COMPANY: S. MEGGA		TITLE: TW00-X640	
DRAWN:	DATE:	CODE:	SIZE:
Kenneth D.	980422	0	0
DRAWING NO:		SHEET 1 OF 2

TW00-X640

FCC ID: CLHSKYHAWK98

Skyhawk HANDSET (CID II)

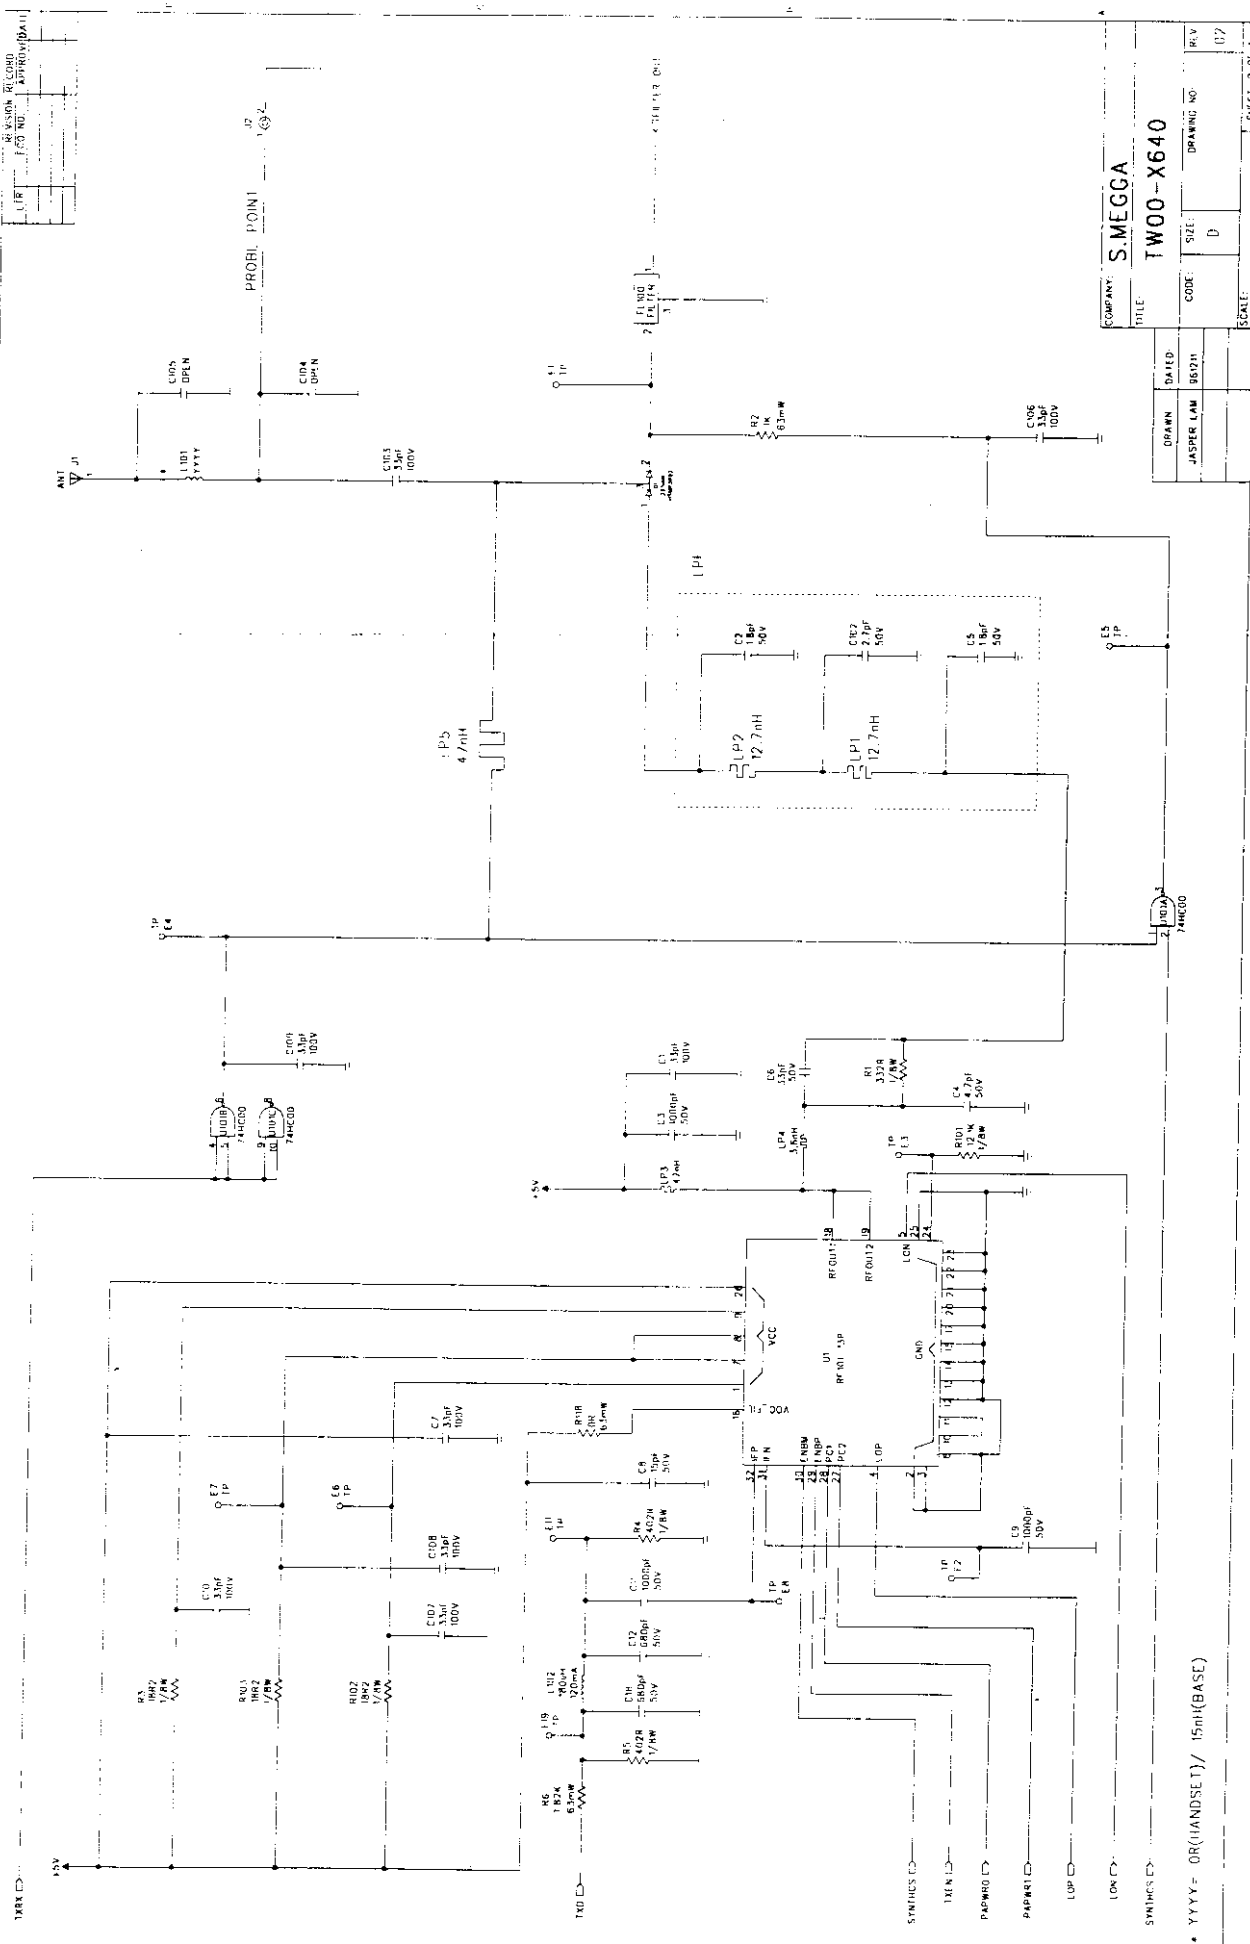
Remark:
Add R2(1K8) and change T1(HF/BC2884R) to improve returnloss.
